COMMUNITY DEVELOPMENT DEPARTMENT

SUBJECT: FP-2020-0013
Apex Southeast No. 1

LOCATION: Southeast corner of S. Locust Grove Rd.
& E. Lake Hazel Rd., in the NW ¼ of
Section 5, Township 2N., Range 1E.

Final plat consisting of 77 single-family residential buildable lots, 2 commercial buildable lots and 13 common lots on 41.63 acres of land in the R-8 and C-C zoning districts.

B. Final Plat (dated: 10/30/20)

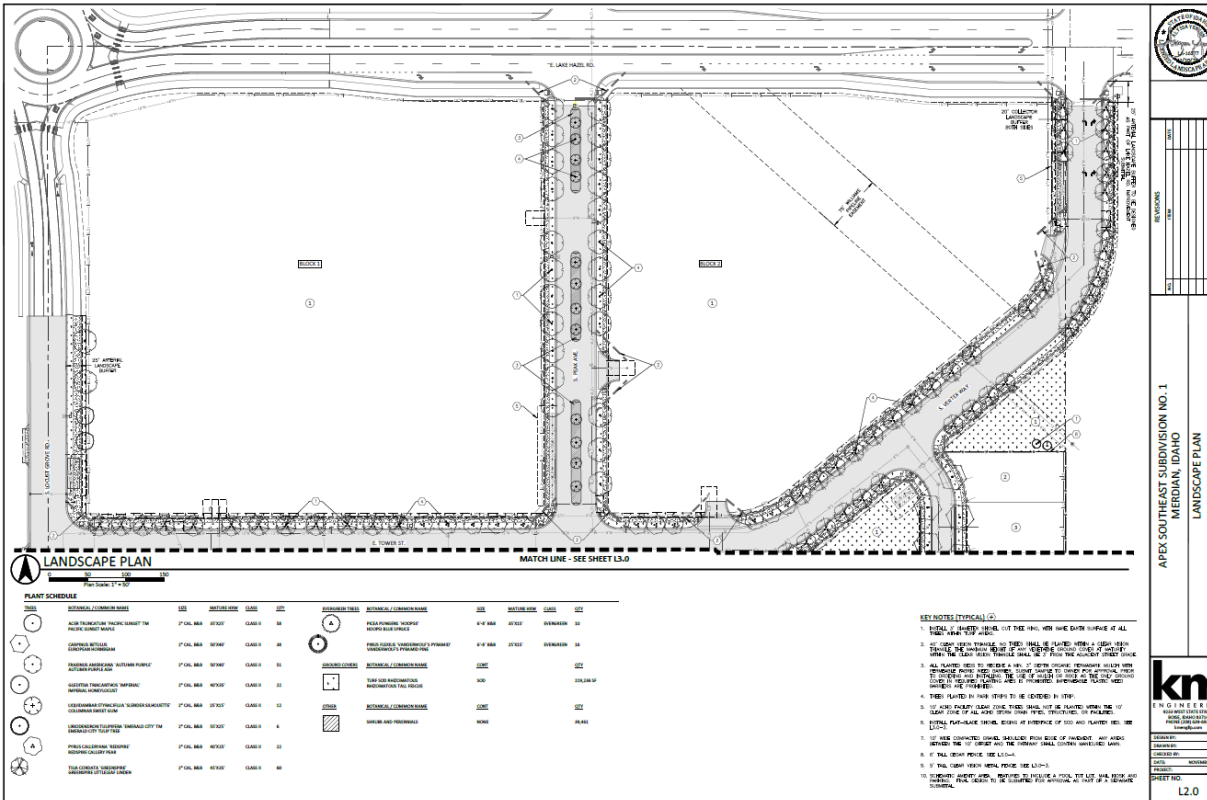
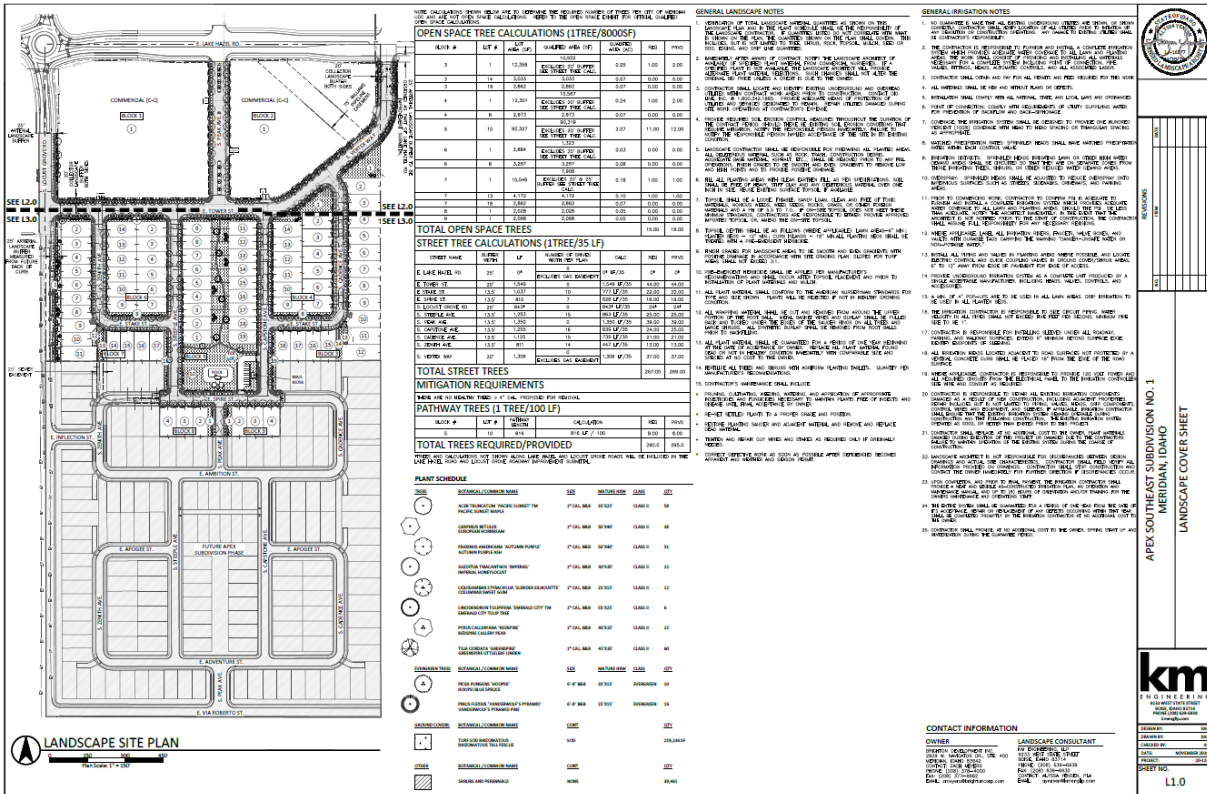
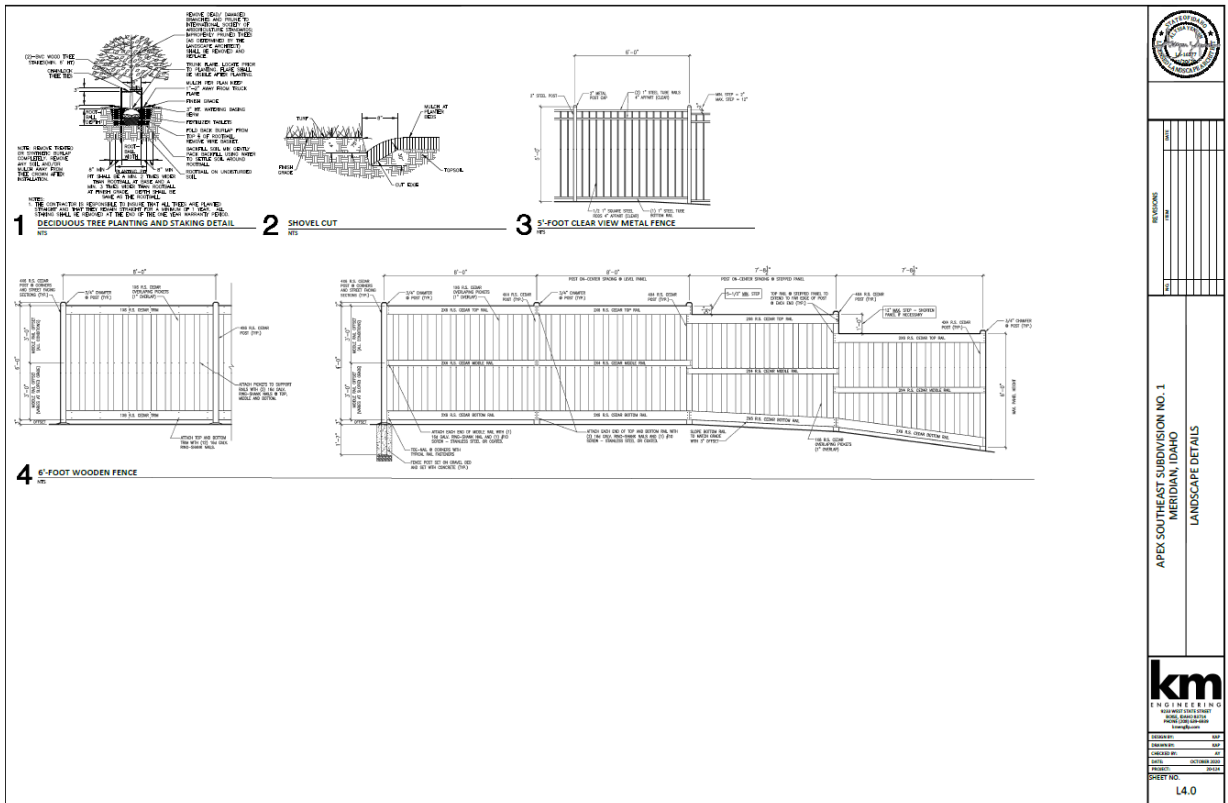
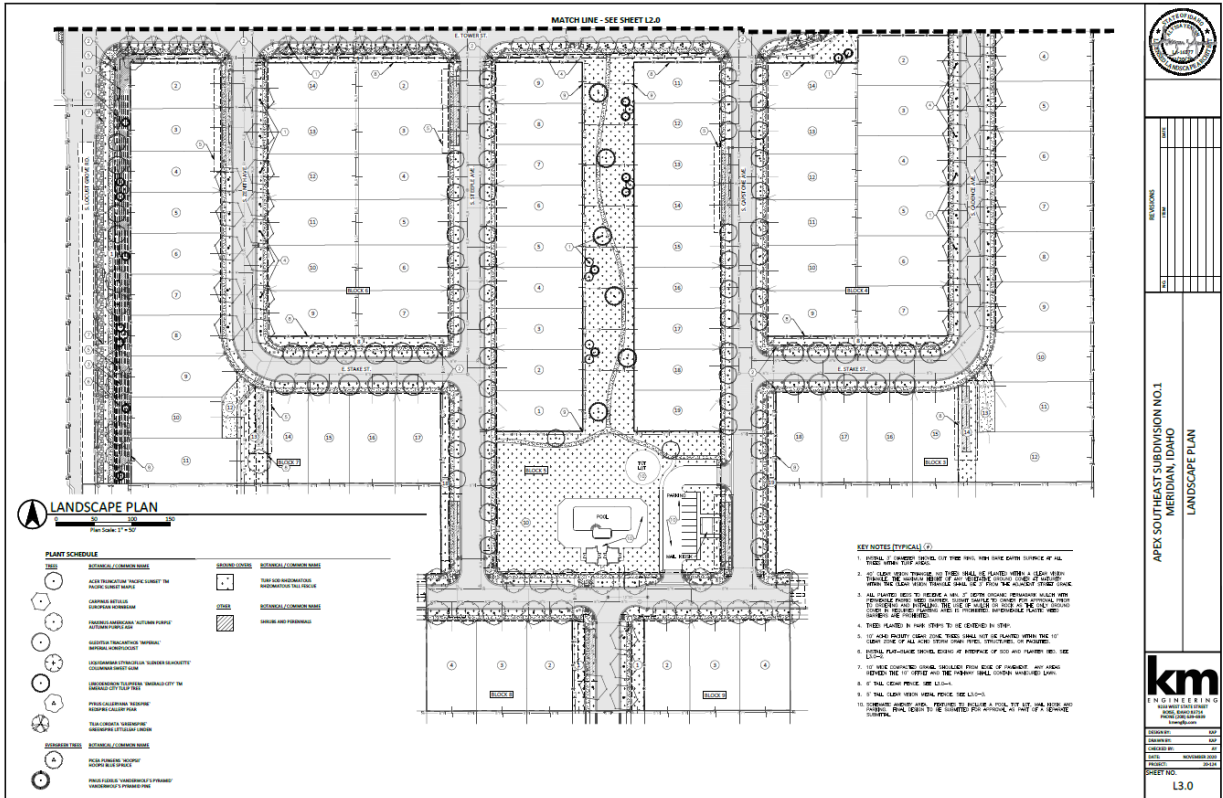
3. Prior to submittal for the City Engineer's signature, have the Certificate of Owners and the accompanying acknowledgement signed and notarized.
4. The final plat prepared by KM Engineering stamped by Aaron L. Ballard, dated: 10/30/2020, included in Section V.B shall be revised as follows:

- a. Replace S. Vertex Way with S. Bloomerang Way with change from E. Tower St. occurring at S. Cadence Ave. intersection, consistent with Ada County Street Name Review approval.

- b. Include the recorded instrument number of the City of Meridian sewer and water easement on the face of the plat on Sheets 2 and 3.
 - c. Note #5: "Lots 1, 14 and 19, Block 3, Lots ~~4 and 1~~ 1 and 8, Block 4, Lots 1 and 8, Block 6, Lots 1, 13, and 18, Block 7, Lot 1, Block 8, Lot 1, Block 9 and Lot ~~5~~ 10, Block ~~4~~ 5, are designated as common lots. . ."

- d. Note #6: "Lot 12, Block 7, and Lot 13, Block ~~13~~ are subject to a blanket easement for common drives to provide access for Lots ~~9, 10, and 11, and 13~~, Block 7, and Lots ~~10, 11, and 12, and 14~~, Block ~~13~~, respectively. Said Lot 12, Block 7 and Lot 13, Block ~~13~~ shall be owned by the Apex Southeast. . . Said Lot 12, Block 7 and Lot 13, Block ~~13~~ are subject to blanket. . ." Include a note requiring the common driveways to be constructed of a paved surface capable of supporting fire vehicles and equipment as set forth in UDC 11-6C-3D.8 in accord with preliminary plat condition #A.8.

- e. Note #13: Include recorded instrument number for ACHD landscape license agreement.
 - f. Note #14: Include recorded instrument number for ACHD public right-of-way⁷ easement (sidewalk).

- g. Note #16: Include all lots subject to the ACHD storm water drainage system easement.
 - h. Note #20: Include E. Tower St. and S. Vertex Way/S. Bloomerang Way in the note.

- i. ~~Depict a minimum 15 foot wide common lot in Block 3 for a micro-path connection to Discovery Park in the vicinity of Lots 6 and 7, Block 3 as required by the Park's Department with the preliminary plat.~~

A copy of the revised plat shall be submitted with the final plat for City Engineer signature.

Emergency Access

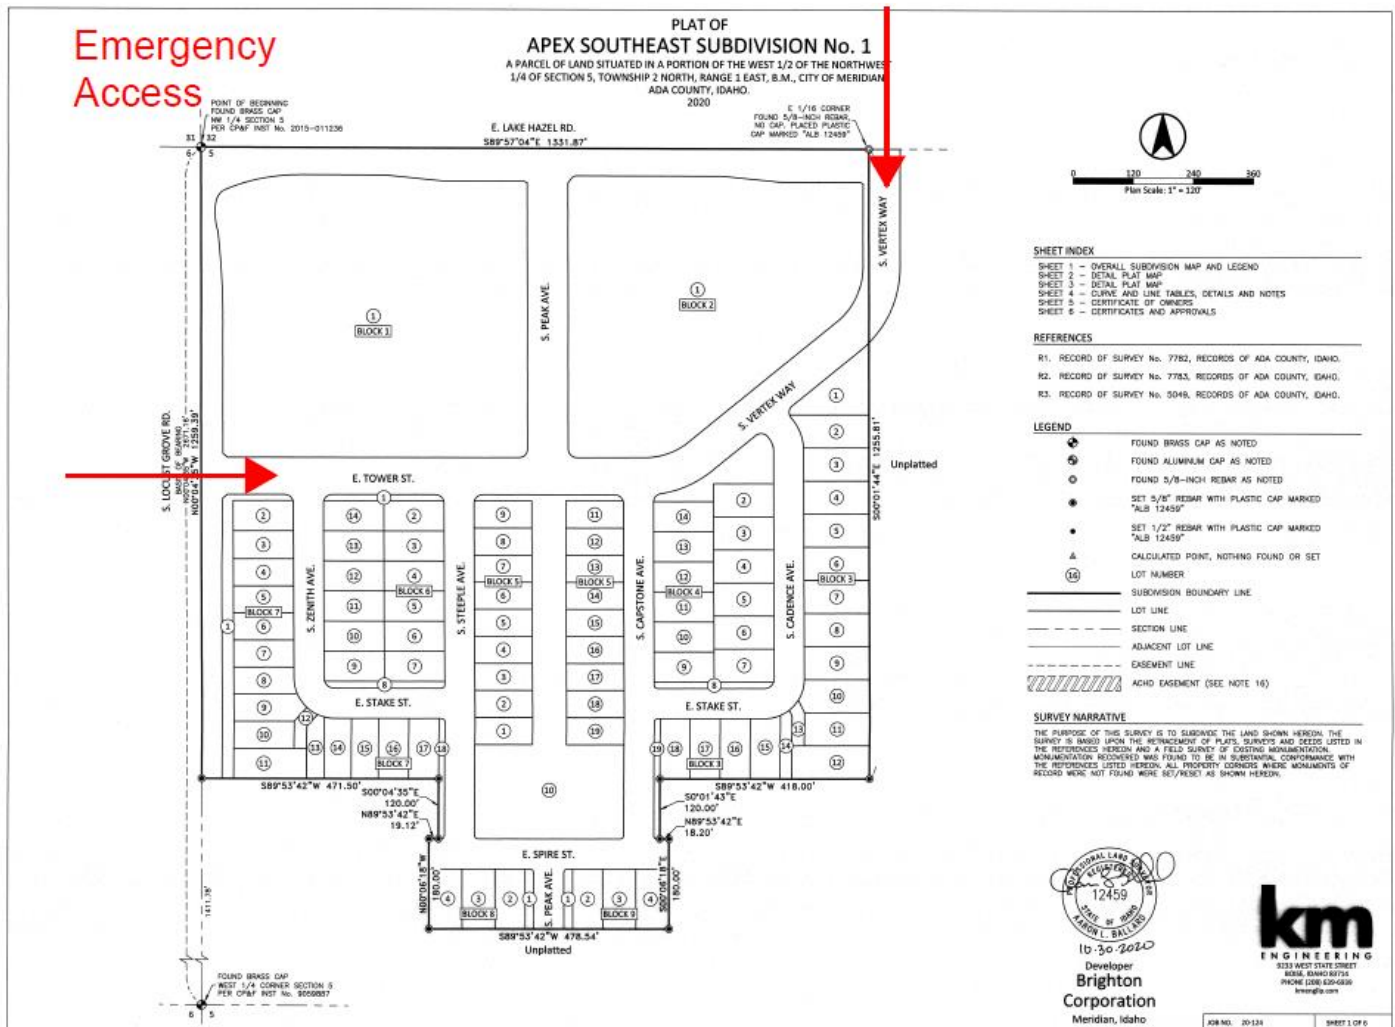
The proposed emergency access exhibit in Section VIII.F has been approved by the Fire Dept.
